Air Compressor Discharge Pipe Leakage

M-561-016

(May 2008)

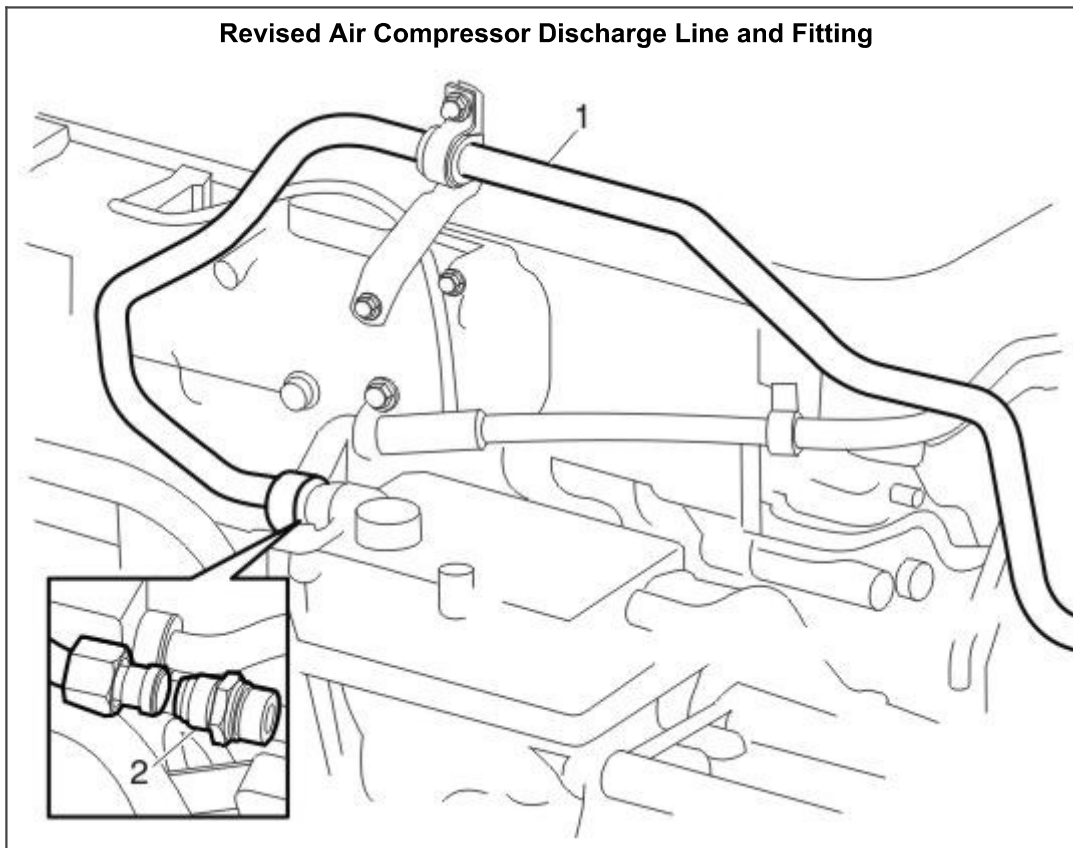
Effective on the dates listed below, a revised air compressor discharge line and fitting was implemented into production on CXU, CHU and GU models equipped with a MACK MP8 engine. The end of the line where it connects to the air compressor was changed from a ferrule-type fitting to a 37-degree flare compression-type fitting to address issues of air leakage at the discharge line, and also to prevent the line from "blowing-off" the compressor cylinder head. Should discharge line "blow-off" or air leakage from the discharge line fitting be encountered, the existing discharge line and fitting must be replaced with the revised line.

Key	Qty.	Part No.	Description	Replaces
1	1	21206841	Tube, air compressor	17QE371M

discharge, MP8 engines	
1	1	21206950	Fitting, 37- degree flare, compression- type	63AM88

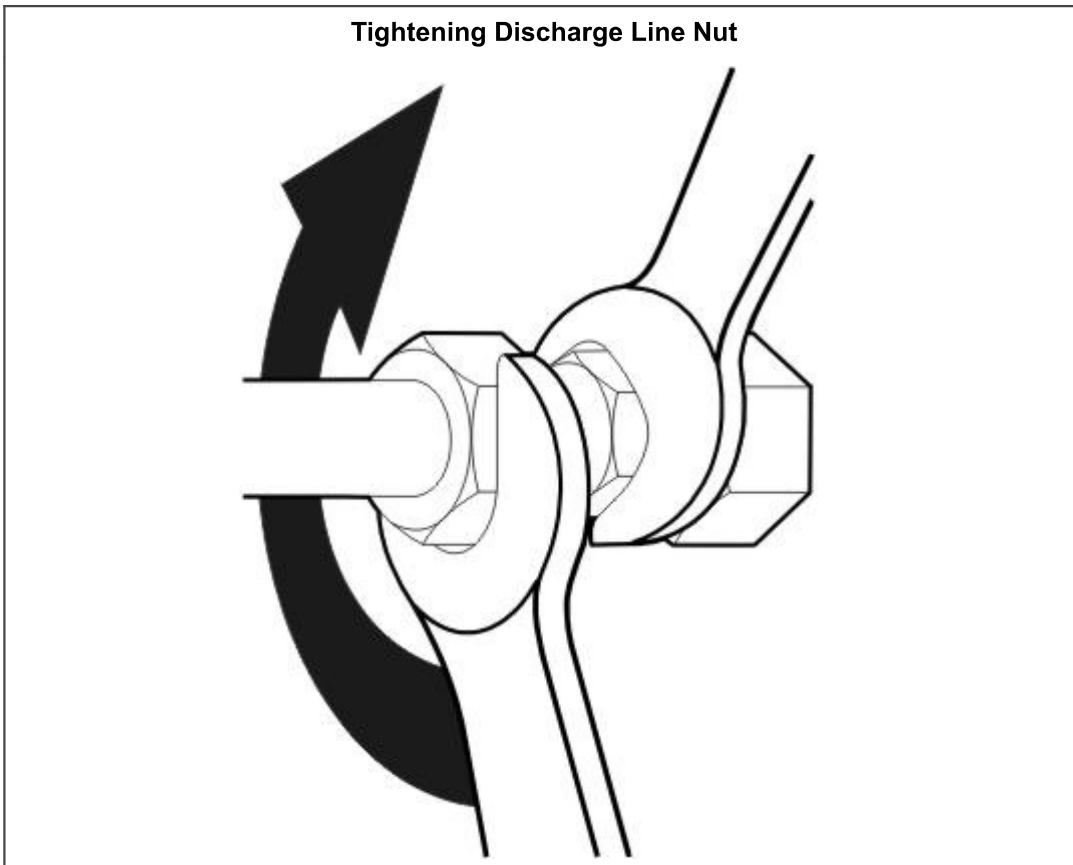
Note: When tightening the line nut, the fitting in the compressor cylinder head must be held with a wrench as shown in the following illustration.

After removing the existing discharge line and fitting, install the replacement fitting (part No. 21206950) into the compressor cylinder head. Tighten the fitting to 130 Nm (96 lb-ft).

Install the replacement discharge line (part No. 21206841). Tighten the line end nut at the compressor cylinder head to 109 N•m (80 lb-ft).
